भारत सरकार – रेल मंत्रालय
अनुसंधान अभिकल्प और मानक संगठन
लखनऊ – 226011
Government of India - Ministry of Railways
Research, Designs & Standards Organization,
LUCKNOW - 226011

MODIFICATION SHEET No. RDSO/2016/EL/MS/0450 Rev'0'Dated 19.05.2016

Deactivation of Vigilance Control Device (VCD) acknowledge from Asstt. Loco Pilot side on Electric locomotives.

Annexure-1

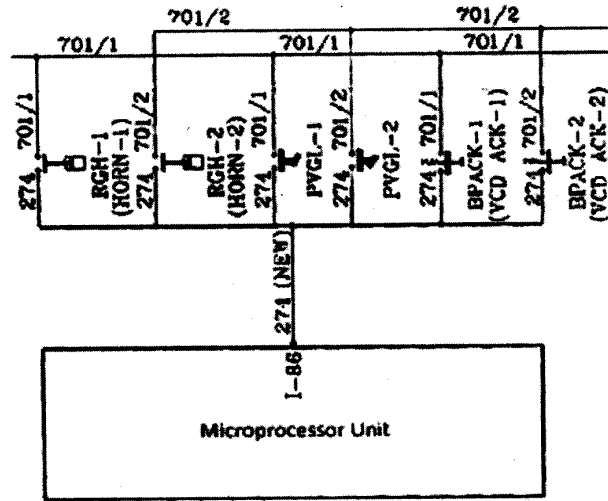
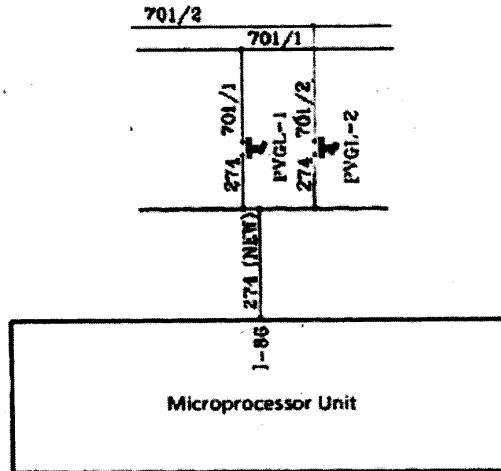
1. Remove : Wires (701/1 & 274) RGH-1 (Horn-1)
Wires (701/2 & 274) RGH-2 (Horn-2)
Wires (701/1 & 274) BPACK-1
Wires (701/2 & 274) BPACK-2
from BD panel which are input to I-86.

2. Remove BPACK-1 and BPACK-2 switches.
3. This modification will deactivate VCD acknowledgement by Horn and ALP side ACK push button switch.

Existing Circuit

Modified Circuit for mpc's v.s. filled locomotives
